City of YUMA

STAFF REPORT TO THE PLANNING AND ZONING COMMISSION
DEPARTMENT OF COMMUNITY DEVELOPMENT
COMMUNITY PLANNING DIVISION
CASE TYPE – REZONE

Case Number: ZONE-3919-2013

Rezone approximately 46.56 acres from the Agriculture (AG) District to the Medium Density Residential/Planned Unit Development Overlay(R-2/PUD) District and Low Density Residential/Planned Unit Development Overlay (R-1-6/PUD) District. The property is located at the northwest corner of Avenue 7½ E and 40th Street, Yuma, AZ.

ATTACHMENT B SITE PLAN

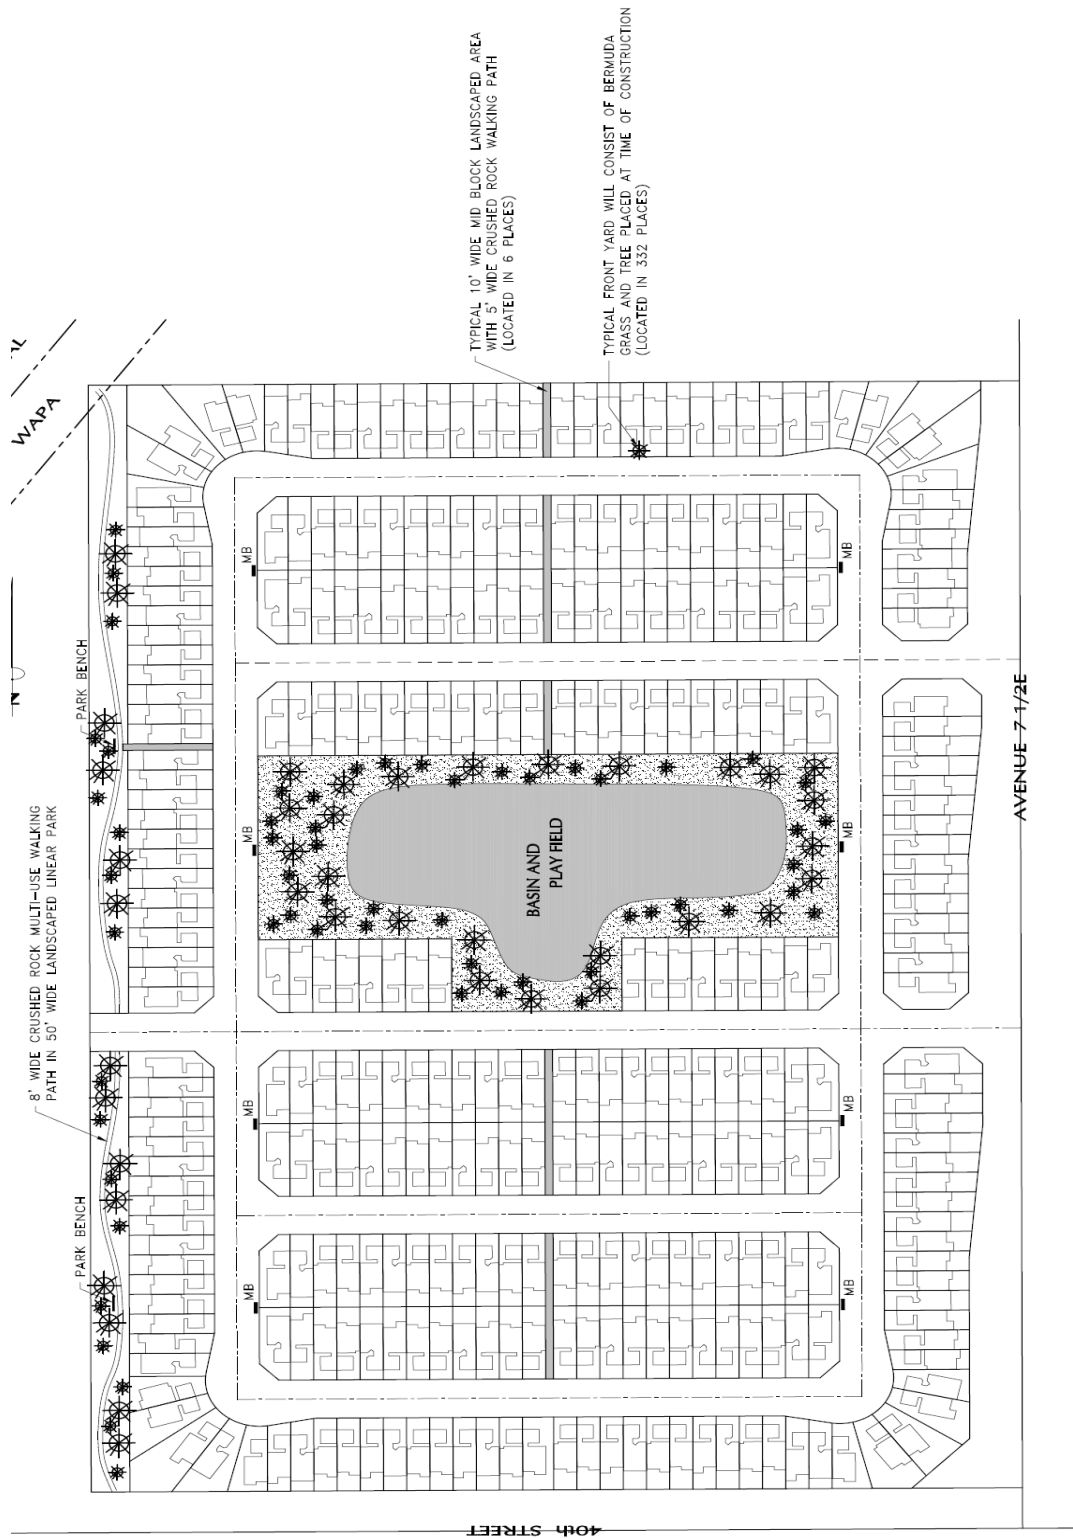
The proposed development encompasses 46.56 acres for the entire development, including the streets. The common area and lots total approximately 34.4 acres. Taking 34.4 acres and dividing by the proposed 332 units, as shown on the site plan (Attachment B), yields an average lot area of 4,513 square feet. Therefore, the proposed development meets the required minimum average lot area of 4500 square feet (under the PUD) per dwelling unit, based on the underlying zoning of R-2.

If the land proposed for this development were to be developed under the R-1-6 or R-2 Districts alone, the developer would be able to build a maximum of 250 units (236 units from the R-2 area and 14 units from the R-1-6 area). A landscaped retention basin would be required for R-2 District development as well as the R-1-6 development. With the PUD Overlay, the developer is permitted to build a total of 332 units, or 82 additional units (25% of the entire project). The PUD Overlay results in a much denser development than the R-2 District alone provides.
